# Technical review of the Environmental Impact Assessment for the Rufiji Hydropower Project in Selous Game Reserve, Tanzania

April 2019

This rapid technical review assesses the “Updated Environmental Impact Assessment Report for 2100 MW Power Generation from the Rufiji Hydropower Project in Selous Game Reserve, Pwani and Morogoro regions, Tanzania” of 18 October 2018 (“the EIA”) that relates to a planned hydropower project to be built at Stiegler’s Gorge in the north of Selous Game Reserve (“the Project”). The Project will involve construction of a 130m high dam on the Rufiji river, creation of a 100km long, c.914km<sup>2</sup> reservoir plus a power plant, a transmission line, workers camps and access roads.

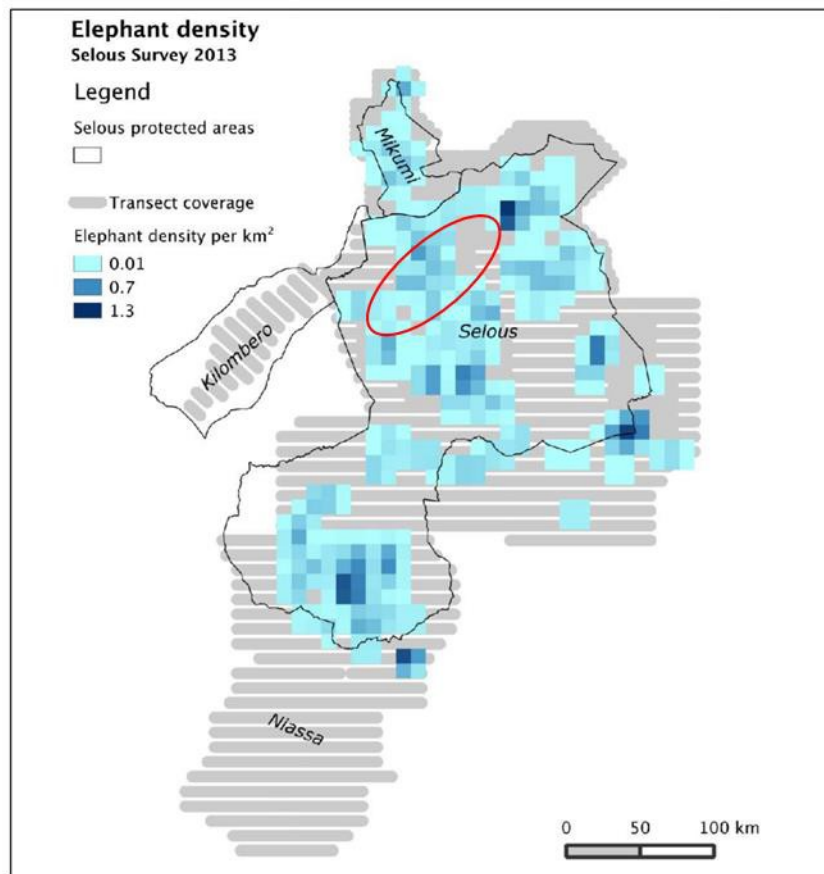
- Maps of the distribution of six 'key species' are presented from 1994 and 2014 using TAWIRI data – all are present in the area of the Project but distributions of terrestrial species that are likely to qualify for Critical Habitat (e.g., African Wild Dog and Black Rhino) are not presented, although both species are known to be present (although in low numbers). Survey effort for other groups (birds, amphibians, small mammals) appears to be very low and not focused on appropriate habitats or locations; this is inappropriate given for example the SGR's status as an Important Bird Area. There is therefore a risk that particularly rare and/or endemic species with specialised habitat requirements may have been missed from terrestrial survey work.

- Data are not presented – and do not seem to have been collected – on the densities of wildlife. Data on wildlife movements are similarly absent. Given the potential barrier effect of the dam and reservoir, this is a significant gap.
